FORD 4R100 "UPDATE HANDBOOK"

FORD 4R100 "UPDATE HANDBOOK"

Since the introduction of the 4R100 transmission in model year 1998, there have been many engineering changes to improve Pleaseability, Reliability and Durability concerns. These changes have affected most every part used in this transmission. This "Update Handbook" will explain each change, the reason for the change, and any parts interchangeability concerns created by the change, along with any part numbers needed to update your transmission.

Figure 2

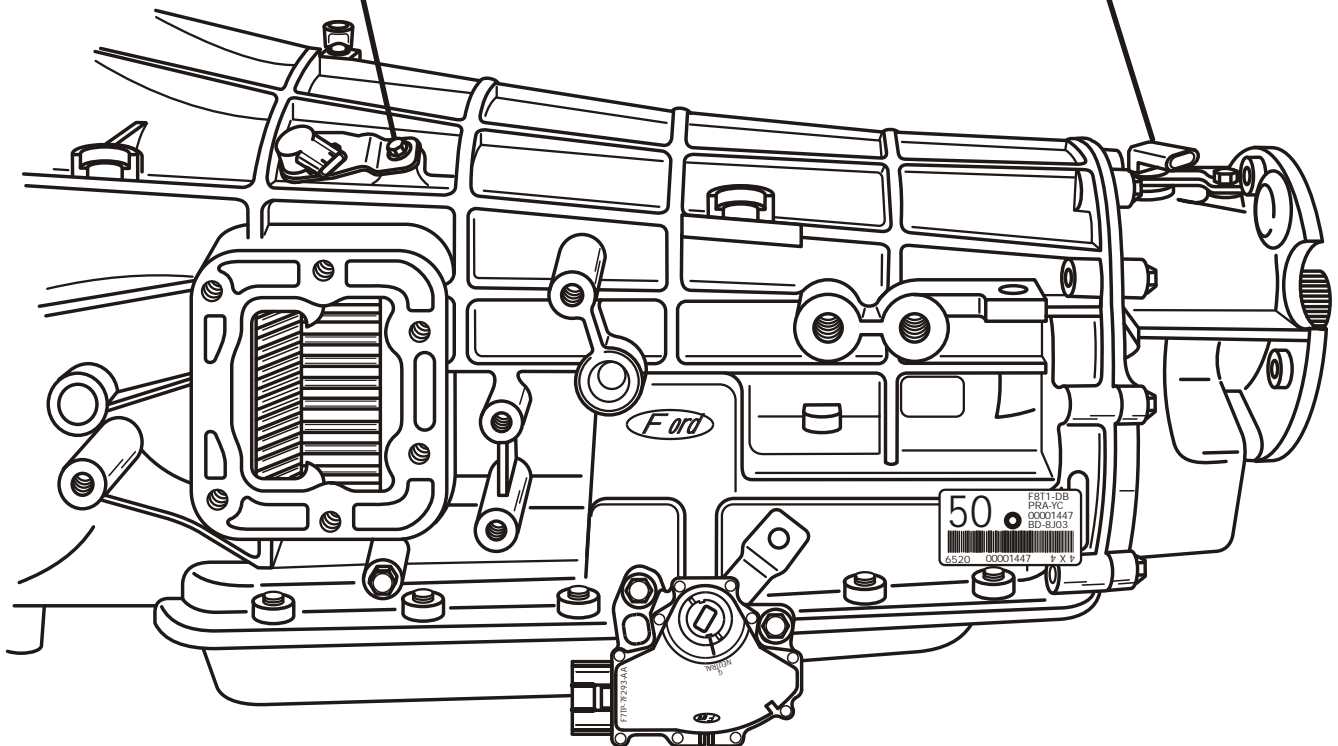
- (2) **TURBINE SPEED SENSOR** - Added to the top front of the case on some models, as shown in Figure 2. We have also provided you with the resistance readings and OEM part numbers on both Turbine Speed Sensors, as the PTO and Non-PTO models use different sensors. Refer to Figure 2 for turbine speed sensor information.

- (3) **OUTPUT SHAFT SENSOR** - Output Shaft Speed sensor was added to the top of the extension housing on some models, as shown in Figure 2. OSS is triggered by an added rotor pressed onto the output shaft, which requires a new tool to position the speed rotor properly *if* it is removed during overhaul, as shown in Figure 3. The park gear is also now pressed onto the output shaft, and the number 13 thrust washer has been changed to a thrust bearing as shown in Figure 3. We have provided you with the resistance reading and the OEM part number for the output shaft speed sensor. Refer to Figure 2 for output shaft speed sensor information.

*PTO Models Only = 496-1244 Ohms Resistance
Part Number F81Z-7M101-BA*

*Non PTO Models Only = 781-1979 Ohms Resistance
Part Number F81Z-7M101-AA*

*All Models = 781-1979 Ohms Resistance
Part Number F81Z-7M101-AA*

Figure 3

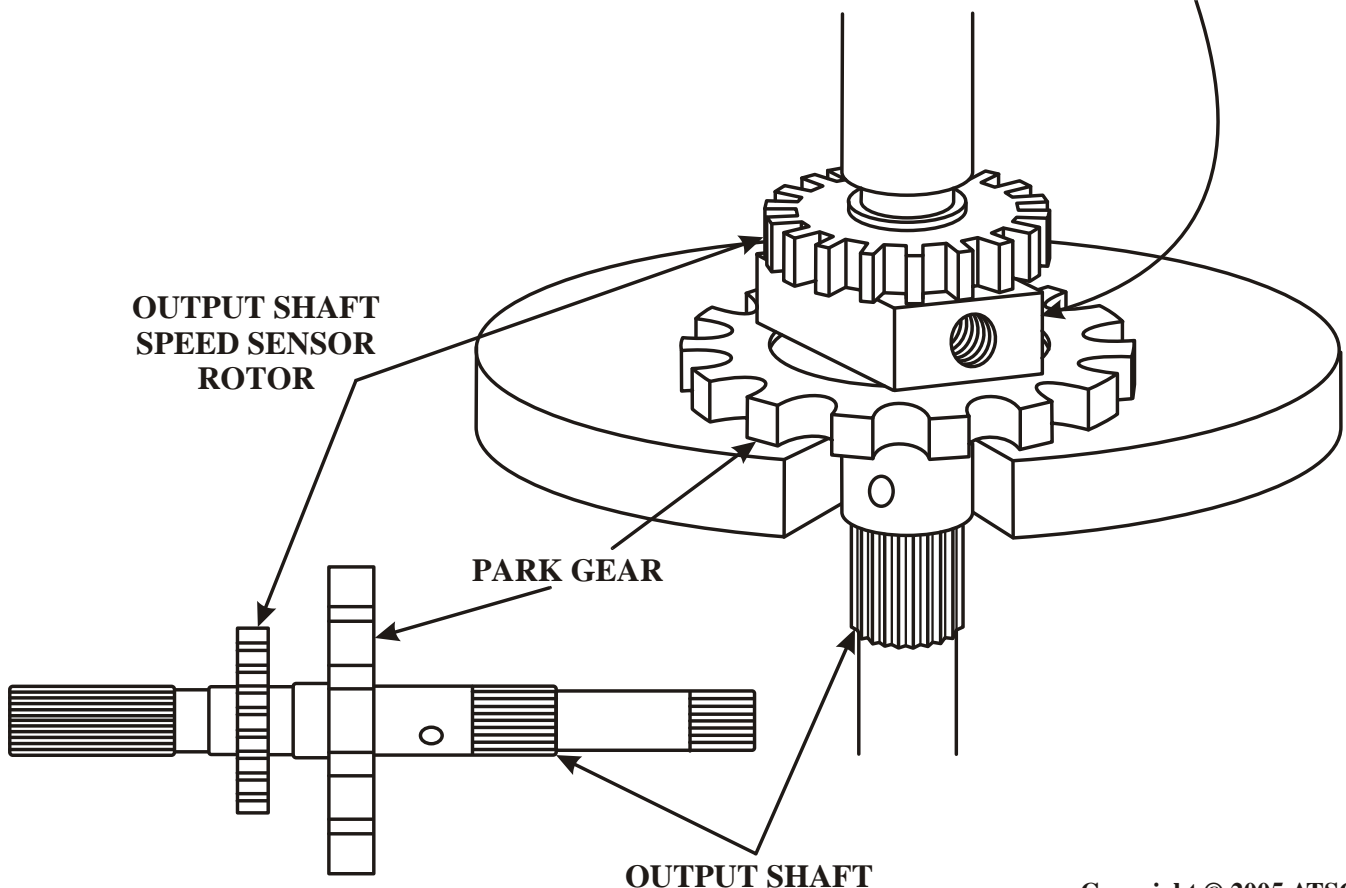
Output Shaft Speed Sensor Rotor is press fit to the output shaft and requires new Spacer Tool, Rotunda No. 307-388 for spacing the speed sensor rotor the proper distance from the park gear, if it was removed from the output shaft during service.

The Park Gear is also press fit to the output shaft, and the number 13 thrust washer, between the case and the park gear has been replaced with a needle bearing.

Figure 4

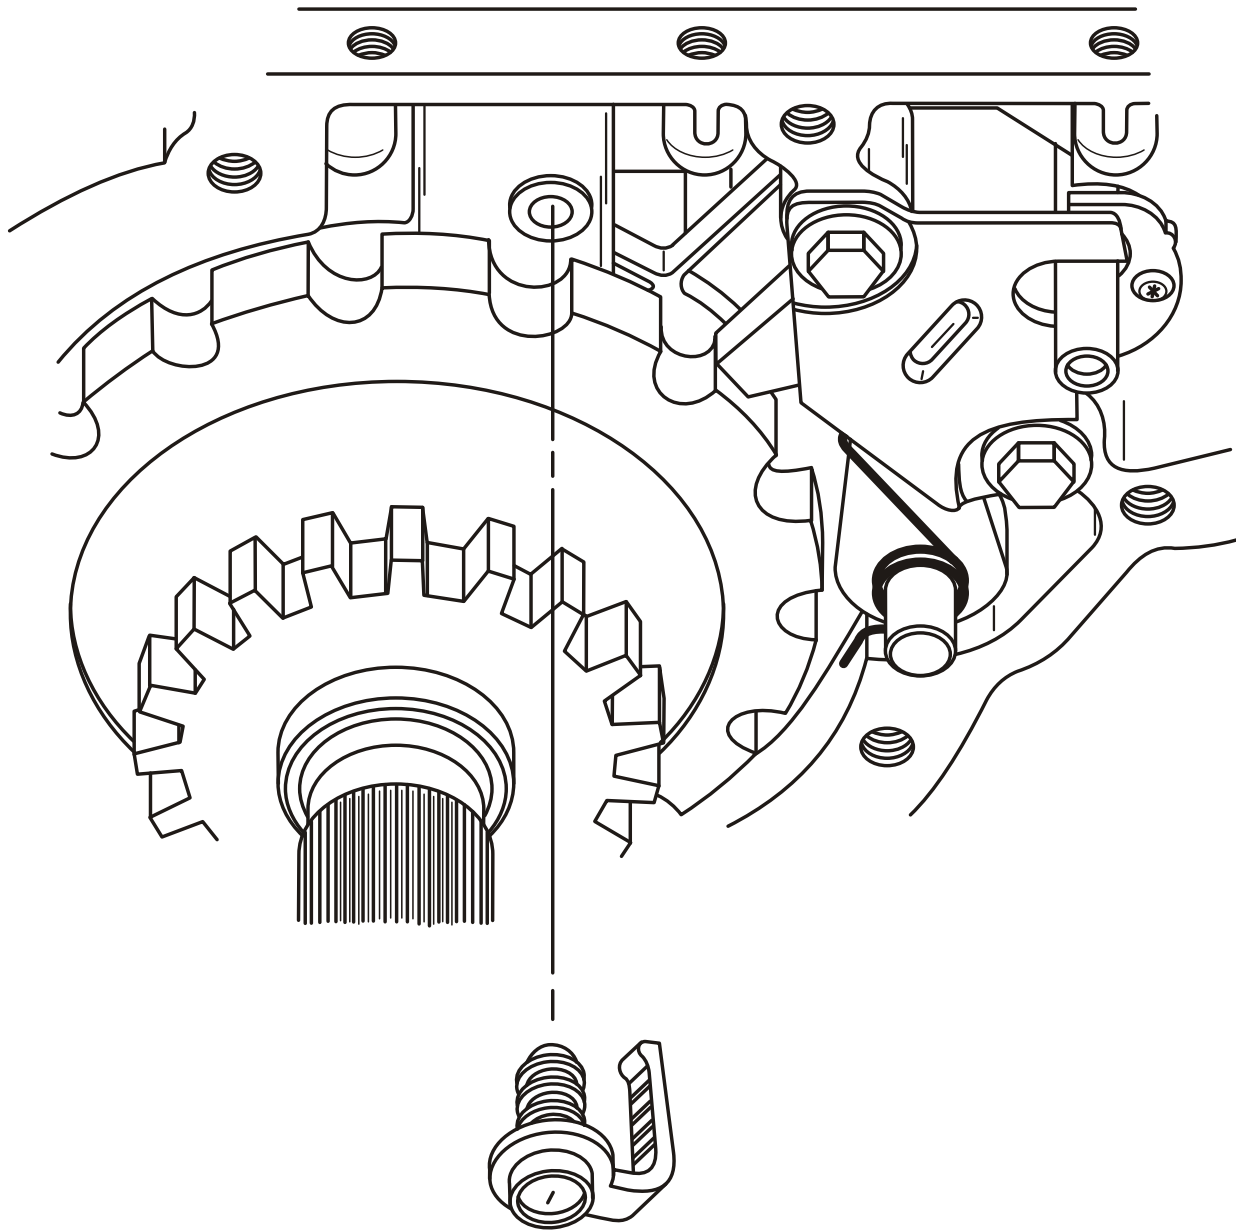
- (4) **LUBE ORIFICE PLUG** - Added to the rear of the case in the lube circuit to provide added lubrication to the extension housing bushing on 2WD models. To retain common cases the 4WD models will also have the lube orifice plug installed, as well as E4OD cases produced after July 24, 1997. Lube Orifice Plug is available under OEM part number F81Z-7E380-AA, and should be replaced on rebuild. Refer to Figure 4.

**LUBE ORIFICE PLUG
FORD PART NUMBER
F81Z-7E380-AA**

Figure 7

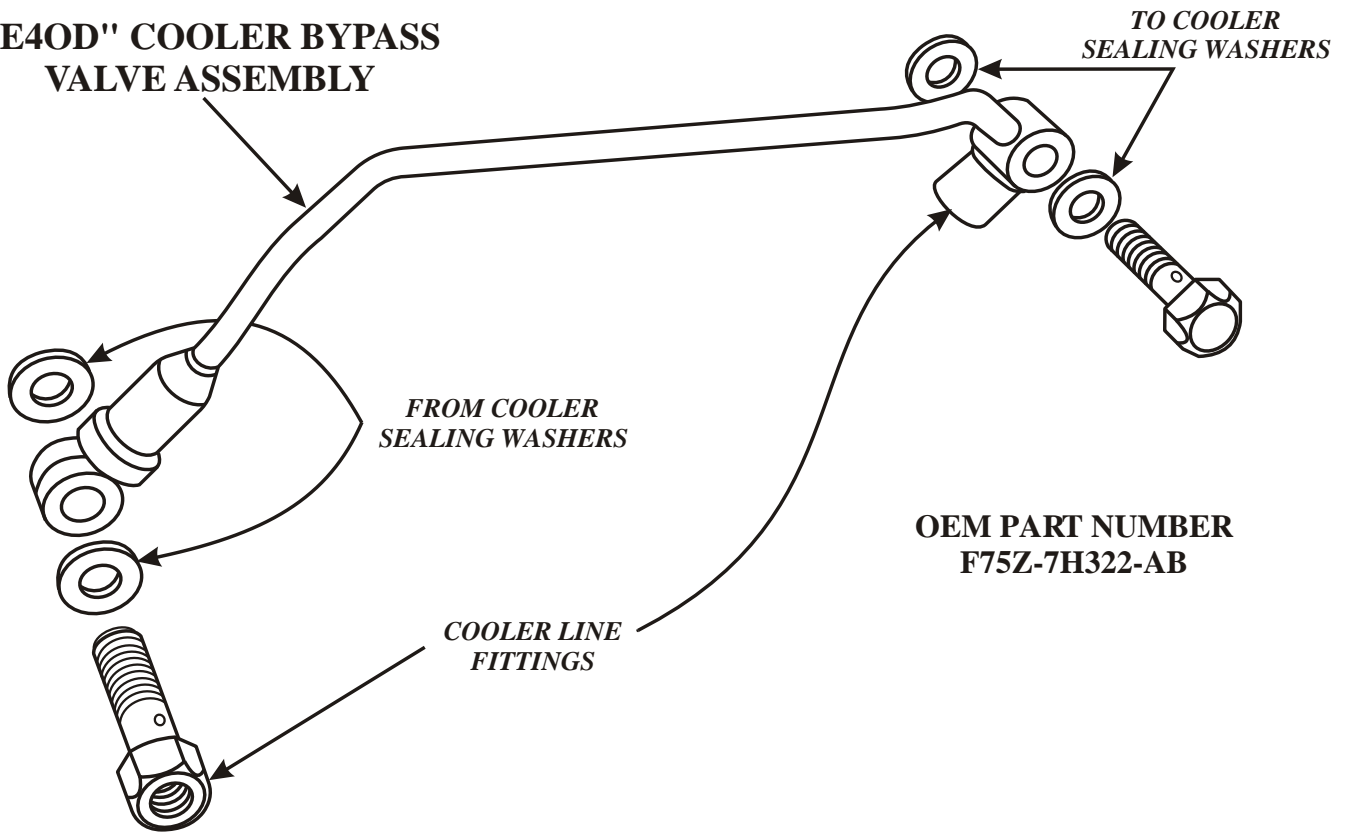
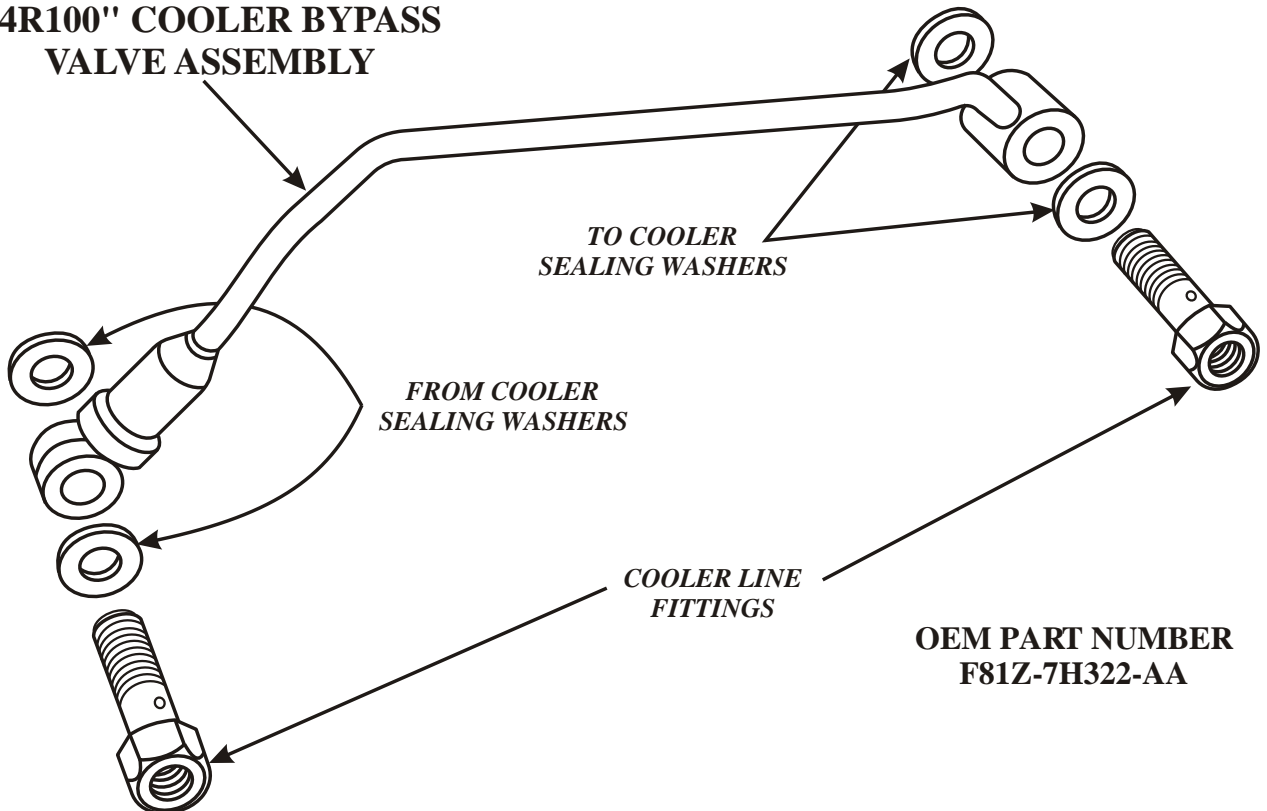
- (7) **COOLER BYPASS VALVE** - Similar to the Cooler Bypass Valve on the E4OD that provides lubrication to the transmission in case of blocked or partially blocked coolers. We have given you OEM part numbers for both and both bypass valves are illustrated in Figure 7.

Figure 8

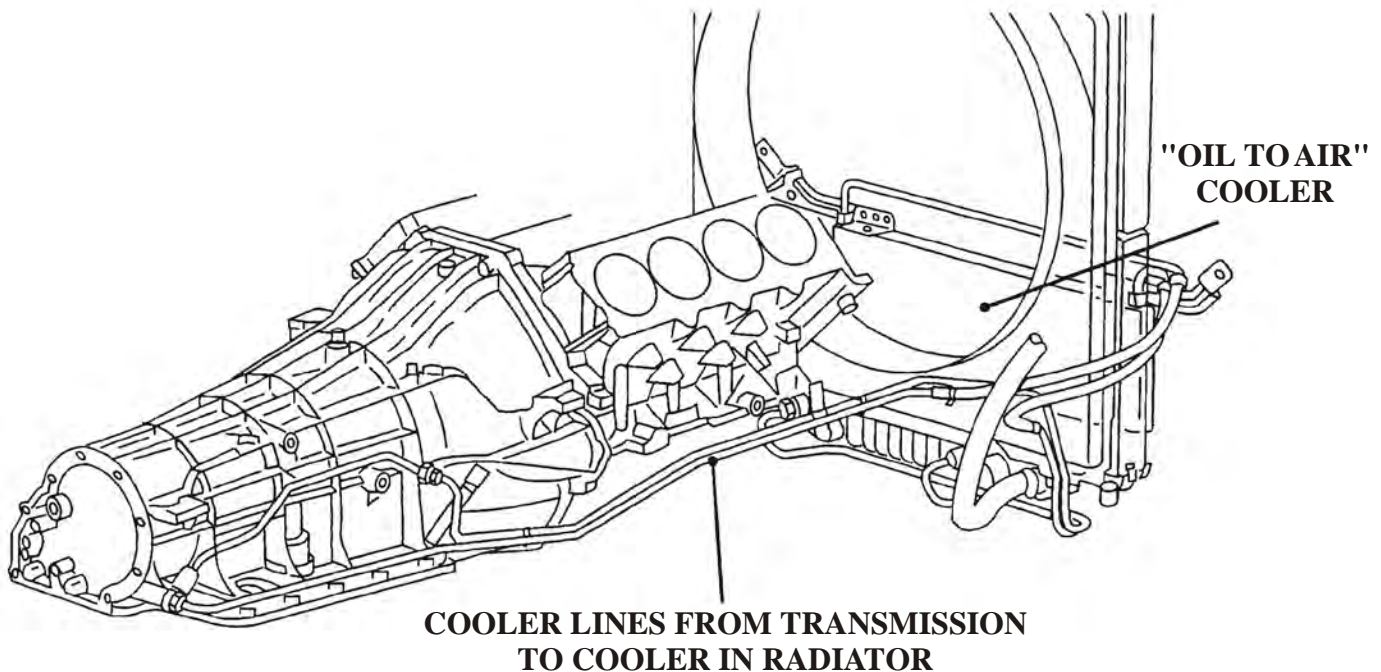
- (8) **TRANSMISSION COOLERS** - Most F-Series vehicles over 8500 GVW equipped with the 4R100 transmission have an external "Oil-To-Air" cooler **only**. Due to the internal design of the "Oil-To-Air" cooler, it cannot be adequately flushed to remove contaminants, and requires replacement during transmission rebuild. The only exception is that F-Series vehicles over 8500 GVW equipped with the 5.4L engine also uses a radiator "In-Tank" cooler in addition to the "Oil-To-Air" cooler. Refer to Figure 8 for transmission cooler information.

Most F-Series vehicles over 8500 GVW equipped with the 4R100 transmission have an external "Oil-To-Air" cooler only. Due to the internal design the "Oil-To-Air" cooler cannot be adequately flushed to remove contaminants, and requires replacement during transmission rebuild.

The only exception is that F-Series vehicles over 8500 GVW equipped with the 5.4L engine also uses a radiator "In-Tank" cooler in addition to the "Oil-To-Air" cooler.

Figure 9

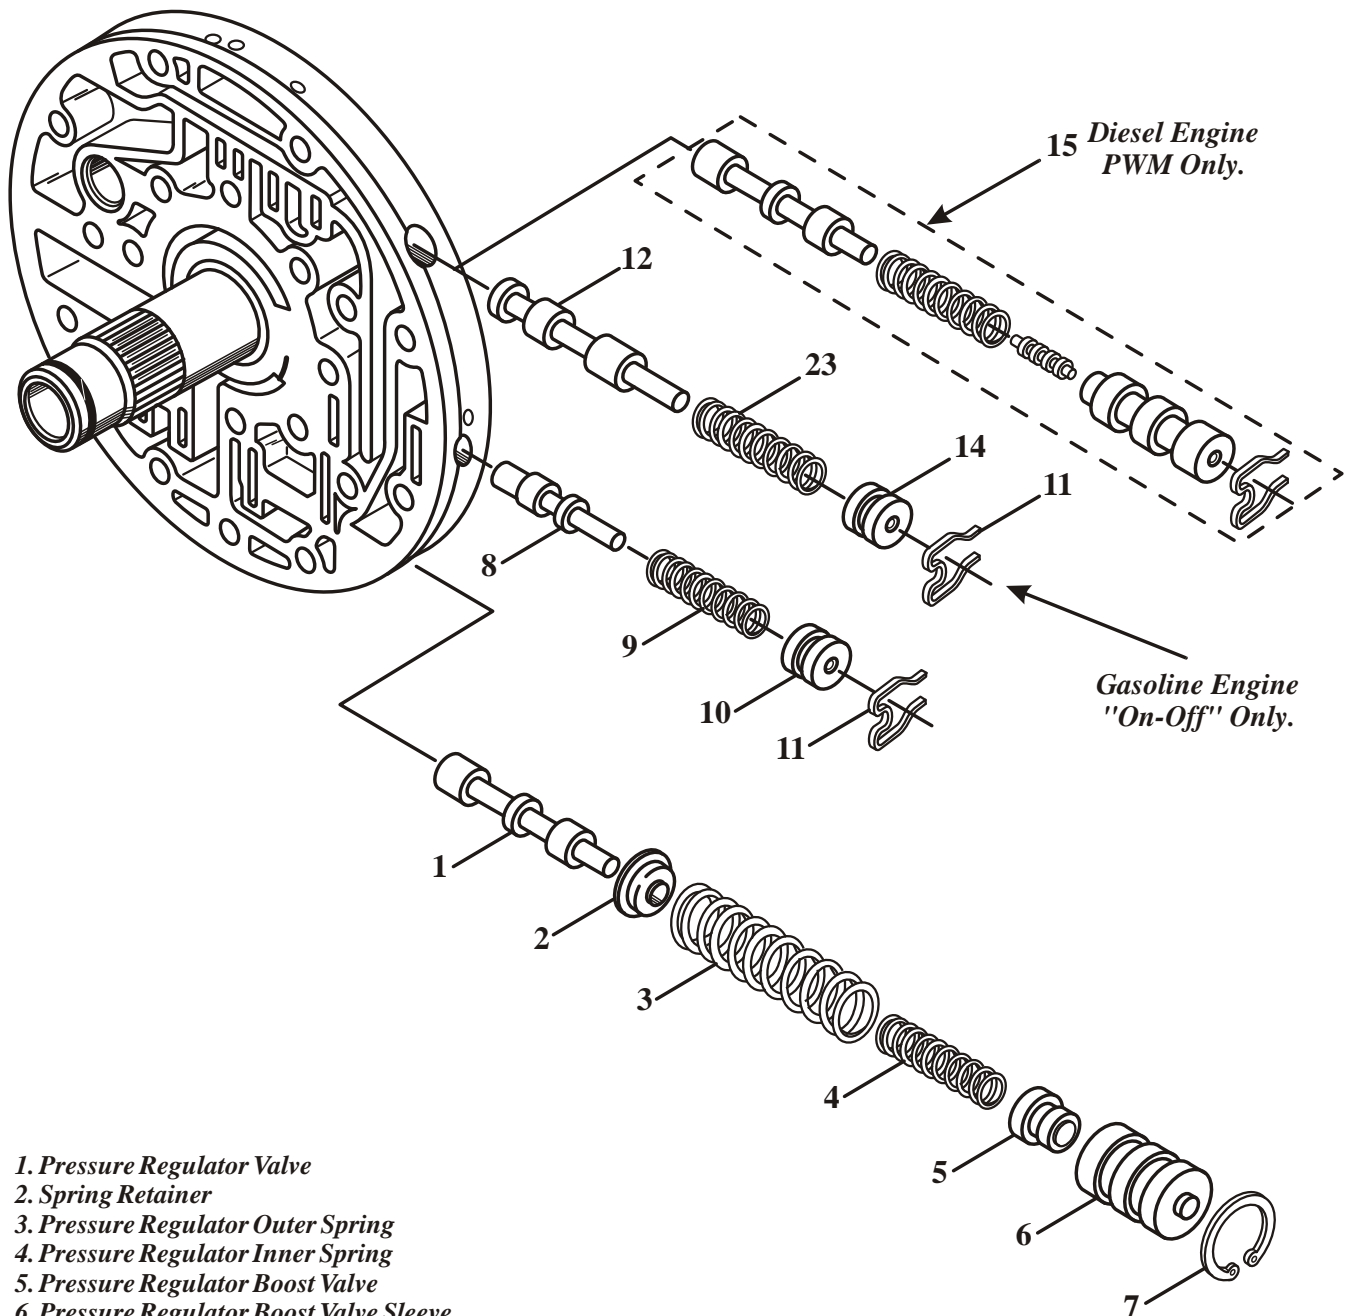
- (9) **FRONT PUMP COVER** - The pump cover is basically the same as the E4OD, but has a different valve line-up in the Converter Clutch Control Valve bore. The gasoline applications all have an "On-Off" lock-up solenoid and the 7.3L diesel applications all have a Pulse Width Modulated (PWM) lock-up solenoid. This changes the Converter Clutch Control Valve line-ups in the pump cover, as shown in Figure 9.
